Subject: DRAFT Response to U.S. EPR Design Certification Application RAI No. 384, FSAR Ch. 3, Questions 3.8.4.11-14
Sent Date: 8/12/2010 5:54:10 PM
Received Date: 8/12/2010 5:54:21 PM
From: BRYAN Martin (EXTERNAL AREVA)

Request for Additional Information No. 384, Supplement 7 (4350, 4351, 4469, 4498, 4527), Revision 0

U.S. EPR Standard Design Certification
AREVA NP Inc.
Docket No. 52-020
SRP Section: 03.03.02 - Tornado Loads
SRP Section: 03.04.02 - Analysis Procedures
SRP Section: 03.08.04 - Other Seismic Category I Structures
SRP Section: 03.09.02 - Dynamic Testing and Analysis of Systems Structures and Components
SRP Section: 03.10 - Seismic and Dynamic Qualification of Mechanical and Electrical Equipment

Figure 3.08.04-11-1—Schematic of Typical Anchorage of Strainer or Basket to Concrete Floor

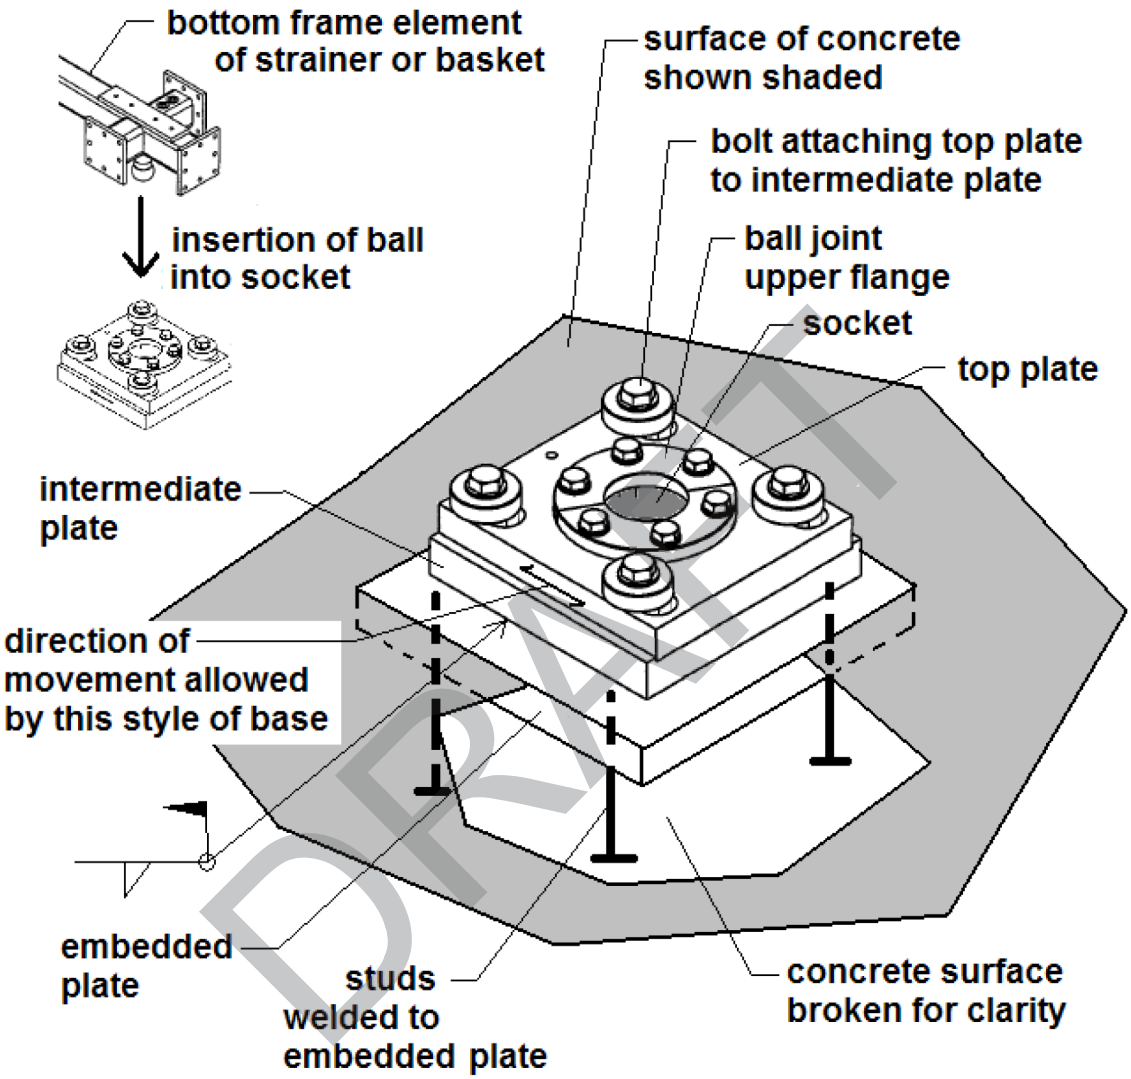
In order for the staff to complete its review and evaluation of the structural integrity of the supports and anchorages as it relates to the abilities of the trash rack, retaining baskets and sump strainers to perform their intended functions, the staff requests that the applicant provide a description of the industry codes and standards applicable to the design and analysis of the supports and anchorages related to the aforementioned seismic category I structures. In addition, the applicant should describe how the structures would be connected and anchored to the concrete walls or base for the retaining baskets and the sump strainer.

The strainers, trash racks, and retention baskets will be anchored to the basemat at discrete locations using a ball and socket joint, which allows for free rotation to minimize thermal stresses. To further minimize thermal stresses, some of the anchorage points will also allow for sliding in one or two directions. Figure 3.08.04-11-1 illustrates a typical ball and socket joint at an anchorage point that allows for sliding in one direction. Similar configurations are used at anchorages that allow sliding in two directions and at those resisting movement in all three directions.

Each of the four strainers has six such anchorage points mounting the strainer frame to the basemat. Each of the two double compartment retention baskets has four anchorage points mounting the basket frame to the basemat, four anchorage points mounting the frame to the side wall, and two anchorage points mounting the top horizontal cross braces to the side wall. Each of the two single compartment retention baskets has at least eight anchorage points mounting the frame to the basemat and at least ten anchorage points mounting the frame to the two side walls. The anchorages to the side walls are similar to those shown in Figure 3.08.04-11-1. The anchorages are divided between those allowing for zero-, one-, and two-direction movement in a way that minimizes thermal stresses and still allows for the complete transfer of all forces to the concrete elements.

At the typical anchorage illustrated in Figure 3.08.04-11-1, a ball is mounted to a structural element that is part of the bolted assembly of the bottom frame of the strainer or basket. This ball is inserted into the socket of the base and held there by the split ball joint upper flanges that are bolted to the anchorage top plate that contains the socket. The top plate is bolted to the intermediate plate of the anchorage, which is field welded to the embedded plate that is anchored to the concrete by means of headed studs or other similar standard concrete anchors.

Figure 3.08.04-12-1—Quadrant of Floor of Double Retention Basket

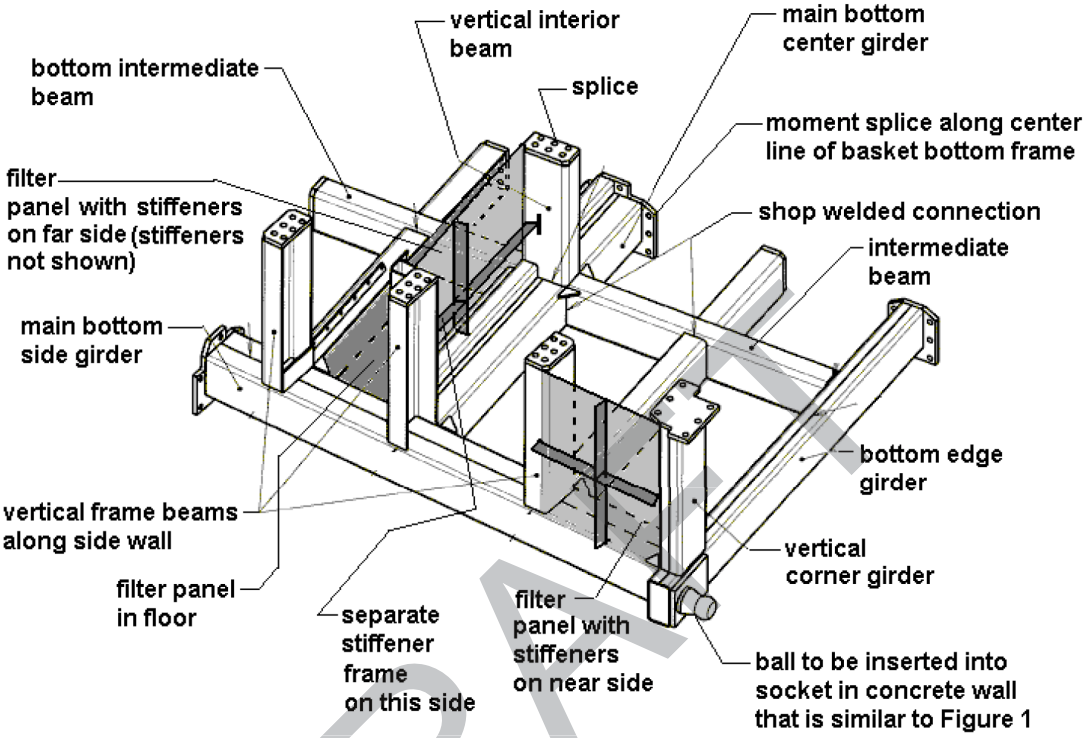
a) A description of the methods and methodology which will be used for structural analysis of trash racks, retaining baskets and sump strainers;

c) A description of the structural elements of the debris interceptor components on which the differential pressure loadings are applied including a discussion of whether the differential pressure loadings will consider credit for the perforated screen surfaces; and,

a) The basic approach for the double retention baskets is illustrated in Figure 3.08.04-12-1, which illustrates a quadrant of the bottom frame for this basket, and in Figure 3.08.04-12-2, which illustrates a typical filter panel for the wall of this basket.

c) Figure 3.08.04-12-2 illustrates a typical filter panel for the wall of a double retention basket, and Figure 3.08.04-12-1 illustrates how such panels are configured in the walls and floor of the basket. Panels on the floors, walls, and roofs (as applicable) of the other baskets and sump strainers have a similar layout. The filter panels are the components that receive the direct static and dynamic pressures from the fluids inside and outside the basket. These pressures may be different inside and outside the basket, resulting in differential pressure. All states of pressure loading will be evaluated to determine the maximum value of this differential loading in both the inward and outward direction. The filter panels will then be evaluated for these pressures, with the inside stiffeners assisting in resisting pressures that are directed inward, and the outside stiffeners assisting in the resistance to pressures that are directed outward. If these devices are not plugged with debris, the pressures would be applied only on the exposed area of the wire cloth mesh. However, if functional testing reveals that these devices will be plugged with debris, then no reduction for the open area will be considered, and the pressures will be applied to the full area that is bounded by the plane of the wire cloth mesh.

Figure 3.08.04-14-1—Attachment of Wire Cloth to Boundary of Panel

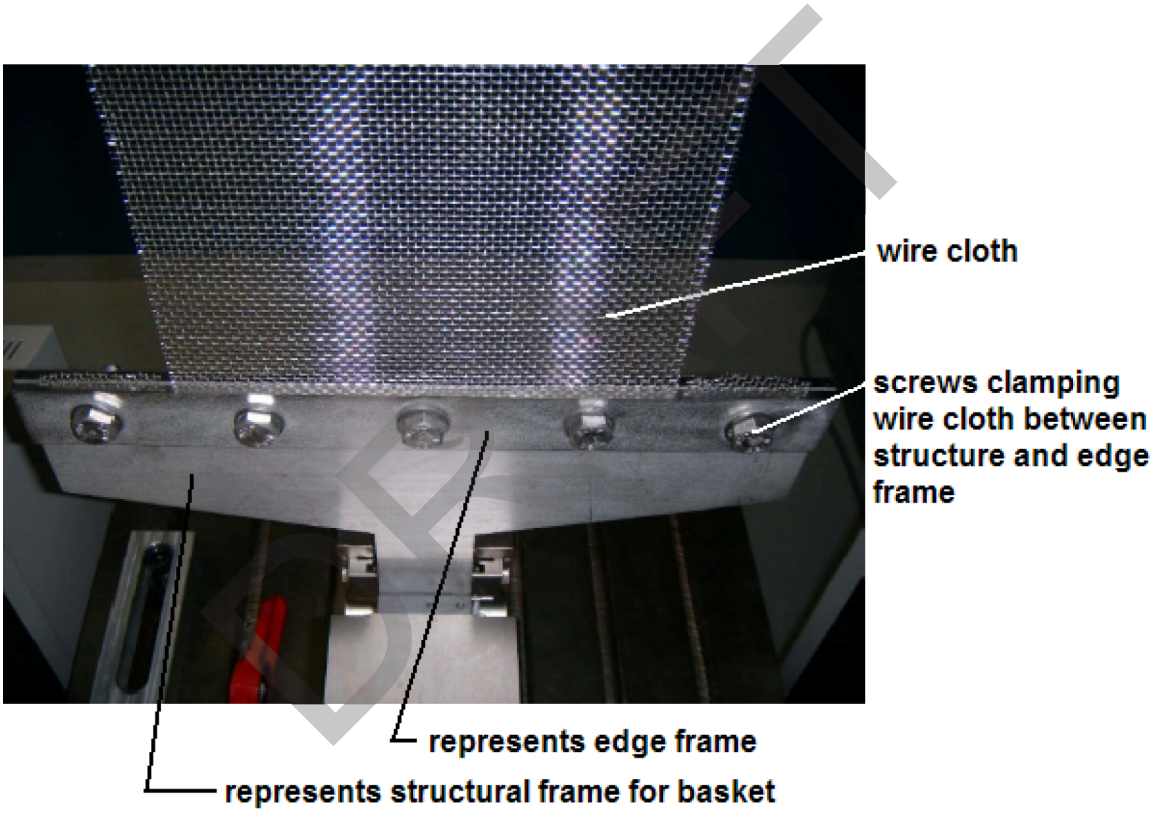
a) Describe the design of the joint and attachments of the screen, and how the screens are attached to the sump strainer to preclude the possibility of debris bypassing the screening, and

b) Provide a justification for assuming that the screens will remain undamaged and there will be no gaps and breaches between the screens and the structural members of the debris interceptor components, such that the operability of the recirculation core-cooling sump pump is not affected during LOCA or SSE events.

Figure 3.08.04-14-1 illustrates a representative design of the connection of the wire cloth to the boundary elements corresponding to a filter panel. This figure is from a model having its various components cut away for clarity and does not reflect the continuity of these components that would occur in the actual device.

The detailed description of the structural design and analysis of the debris interceptor components, including the justification of the structural integrity of the connections such that there are no gaps and breaches between the screens and the structural members of the debris interceptor components, will be provided in the structural evaluation and stress margin report per the ITAAC items added in the Response to RAI 384, Question 3.08.04-11.
